**ADDENDUM NUMBER**

**04**

**March 26, 2024**

**PROJECT: MORGAN COUNTY EVENTS CENTER  
ARCHITECT: GOODWYN MILLS CAWOOD  
OWNER: MORGAN COUNTY COMMISSION**

**G1 RECEPTION WEST**  
SCALE: 3/8" = 1'-0"

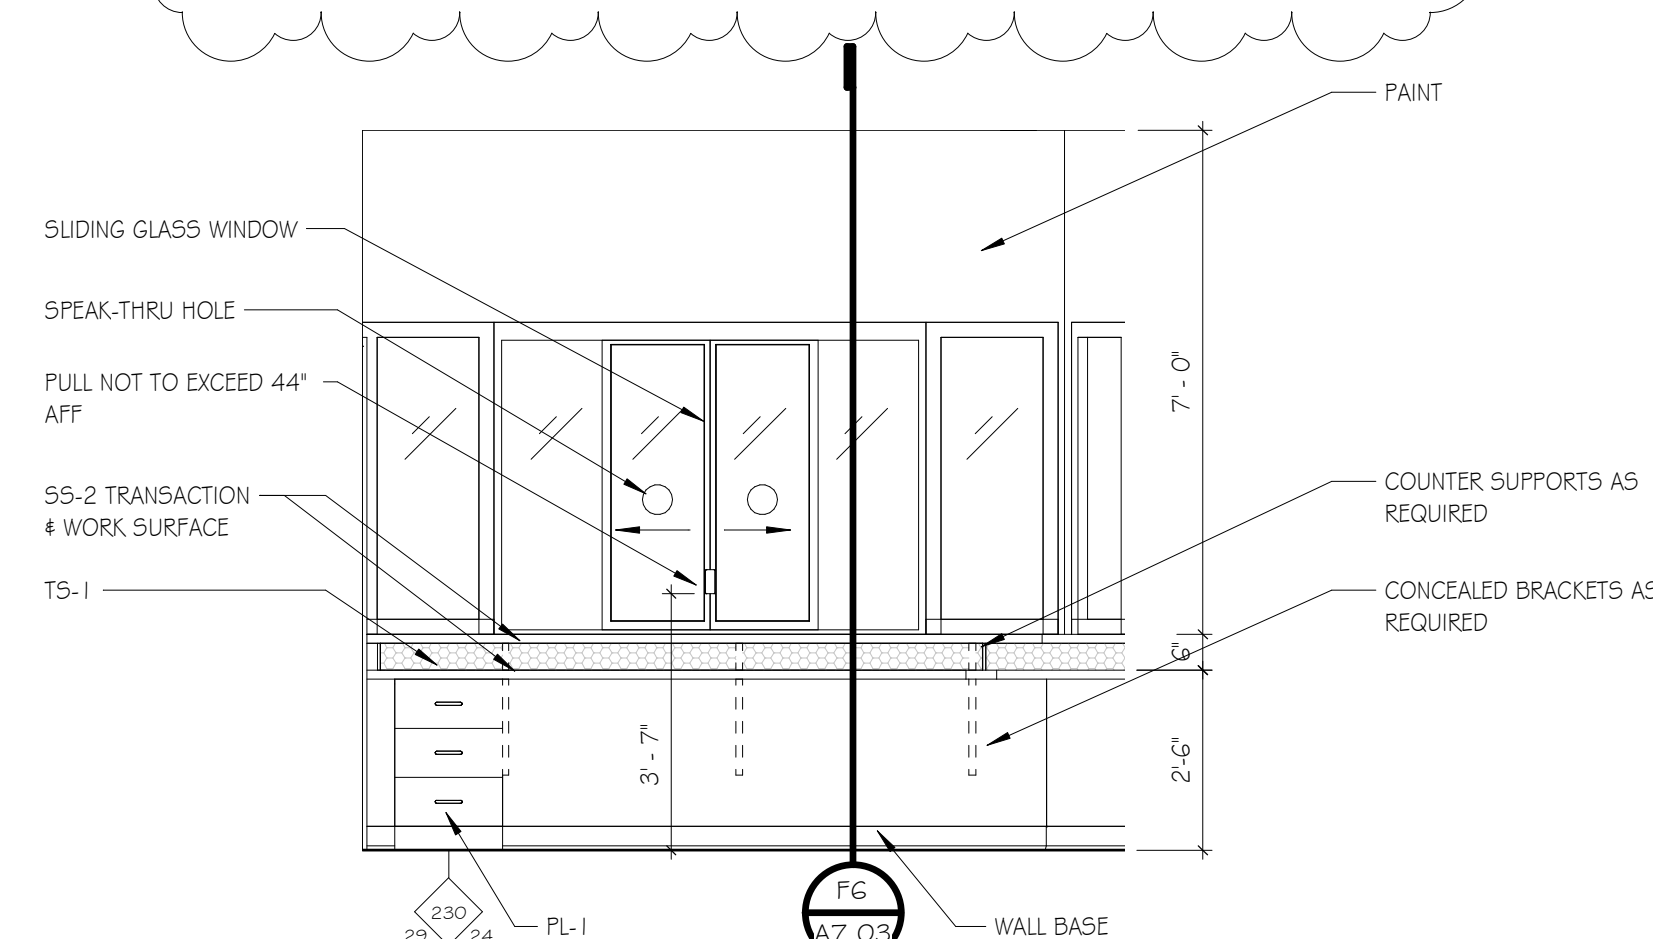
- A. C-102 – Site Layout Plan – corrected with bollards and Add.2 items combined. (Revision 3/26/2024)
- B. A7.03 – Interior Elevations – Reception West window and door dimensions. (Revision 3/26/2024)
